**Bayside Planning Panel**

Item No	6.3
Application Type	Section 96(2) Application – Modification to Residential Flat Building
Application Number	DA-2014/180/02
Lodgement Date	31 January 2017
Property	6-8 John Street, Mascot Lot 8 and 9 in DP 939729
Owner	Segnic Pty Ltd Bibil Pty Limited
Applicant	Edifice Design Pty Ltd
Proposal	Section 96(2) Application to modify Development Consent No. 14/180 to increase the number of residential apartments from 39 to 52 units and reduce the number of car parking from 70 spaces to 55 spaces to align the proposal with the Apartment Design Guide, increase the height of the development by 2.53 metres to 47.78 AHD and modifications to conditions.
No. of Submissions	Five objections
Cost of Development	N/A
Report by	Angela Lazaridis- Senior Development Assessment Officer

## Planning Assessment Report

<b>Application Number:</b>	14/180/02
<b>Date of Receipt:</b>	31 January 2017
<b>Property:</b>	6-8 John Street, Mascot Lot 8 and 9 in DP 939729
<b>Owners:</b>	Segnic Pty Ltd Bibil Pty Limited
<b>Applicant:</b>	Edifice Design Pty Ltd
<b>Proposal:</b>	Section 96(2) Application to modify Development Consent No. 14/180 to increase the number of residential ap

Figure 1 – Location of Proposal and Surrounding Buildings

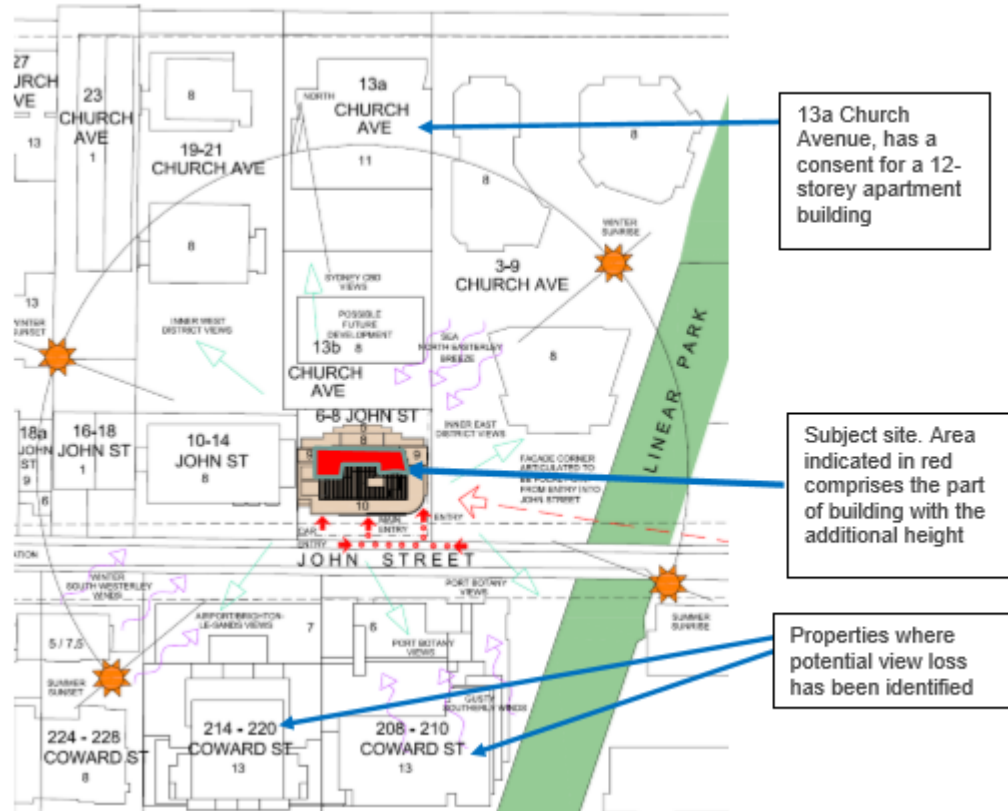
It is evident that this consented proposal at No.13 Church Avenue will serve to impact the views northwards from the properties on Coward Street. This means that even without the limited additional height as part of this S96 proposal, the northern views from the properties on Coward Street will be inhibited as a result of an approved scheme. This clearly reduces the extent of any view loss which is purported to occur as a result of the S96 application at the subject site. The factors outlined above are illustrated in Figure 1 below.

It is clear from the Figure 1 and the information above that any view loss arising from the proposed S96 application will be minimal given the small scale of the intrusion above the
